RECALL BULLETIN:
10420FRV

PRODUCT(S) AFFECTED:
Boulder Classic,
Encounter

SUBJECT:
Install new
Manufacturer
Federal
Certification
Tag

ISSUE DATE:
April 2010

Figure 1

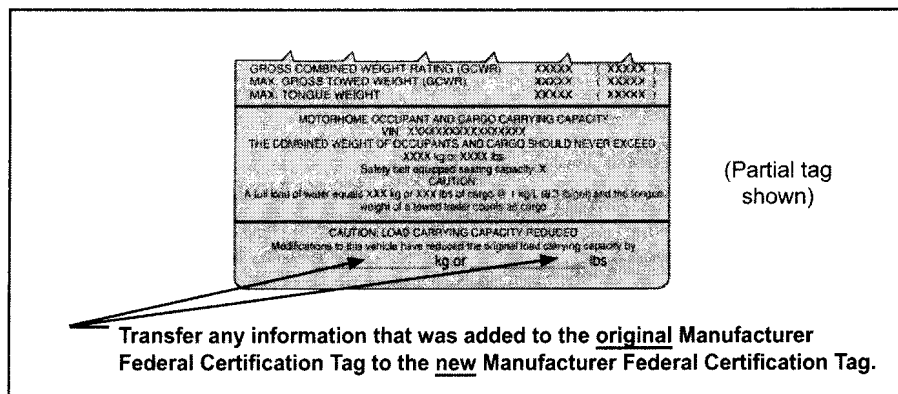
Fleetwood RV, Inc., has discovered that on the identified motor homes, the figures related to the front and rear tire pressure, appearing on the Manufacturer Federal Certification Tag, are incorrect. The correct front tire pressure is 95 PSI (655 KPA) and the correct rear tire pressure is 100 PSI (690 KPA).

1. Locate the original Federal Certification Tag, adhered to the wall behind the driver's seat.
2. Record any additional weight information (if present) that was written on the original Manufacturer Federal Certification Tag due to the addition of options after the motor home was manufactured. (See Figure 1.) Transfer this information to the new Manufacturer Federal Certification Tag using a black, fine point, permanent marker.

3. a) If the original Federal Certification Tag is loose or peeling, remove it and discard. Remove any adhesive residue in the application area using a clean shop cloth slightly dampened with isopropyl alcohol.
- b) If the original Federal Certification Tag is adhered securely in place, use a black permanent marker to deface it.
4. Peel and tear approximately 1" from the top of the adhesive backing of the new Federal Certification Tag. (This will allow control of the application.) Slowly apply the new Tag directly over the original, using your fingers to smooth down newly-applied areas. (If the original Tag was removed in Step 3a, apply the new Tag in the same location as the original.) Continue to remove backing, working from top to bottom, until the entire tag completely adheres to and covers the original tag.
